CITY OF ALBUQUERQUE

July 10, 2024

**Re: West Mesa Ridge Apartments
701 Coors Blvd NW
Traffic Circulation Layout-DFT Approval
Engineer's/Architect's Stamp 05/29/24 (J11D048)**

1 Site Plan
1" = 20'-0"

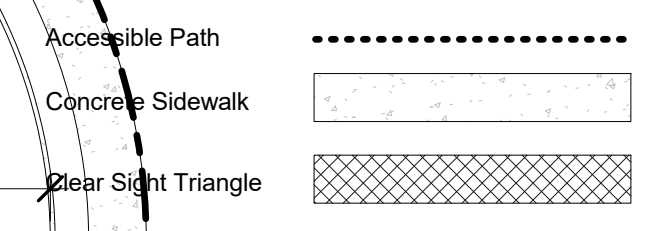
The conceptual TCL submittal received 06/12/2024 is approved for DHO and/or DFT submittal. When submitting this project through the building permit process, a full Traffic Circulation Layout will need to be submitted and approved prior to building permit. **When submitting a TCL for Building Permit Approval, provide the following:**

- 1. An approved infrastructure list.**
- 2. Agreement from the adjacent property owner (self).**
- 3. Sidewalk easement as mentioned in the comment letter.**
